## **Austausch Kühlflüssigkeit** **Exchange Coolant**

# SERVICE BULLETIN

## CHANGE OF COOLANT SPECIFICATION ON ROTAX, ENGINE TYPE 912 AND 914 (SERIES)

<b>Abt. Flugtechnik</b>	Airworthiness Directive No. A-2004-004R1	Reference: FL206-1/132-04	
	<b>Rotax 912 A Series engines</b> <b>Rotax 912 F Series engines</b> <b>Rotax 912 S Series engines</b> <b>Rotax 914 F Series engines</b>	Registration mark: without	
		Page: 1	Sheet: 3

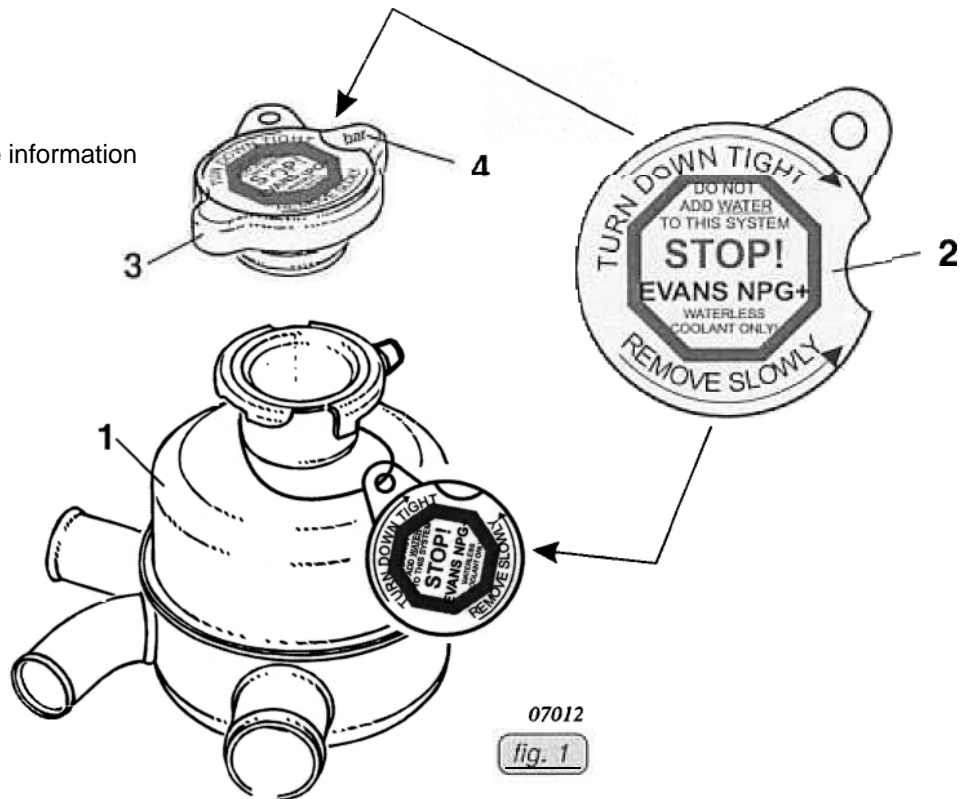
(see fig. 1)

The coolant is to be replaced according to the Maintenance Manual, **current** issue.

◆ NOTE: On the radiator cap (3), to identify the new coolant, the warning label (2) is to be affixed so that the opening pressure data (4) is visible.

The following drawings should provide additional information: See fig. 1

- For new engine deliveries the sticker will be temporarily attached to the expansion tank.
- The sticker has to be affixed to the radiator cap in accordance to the aircraft manufacturer's instruction.

- 1 Expansion tank
- 2 Warning sticker
- 3 Radiator cap
- 4 Excess-pressure information
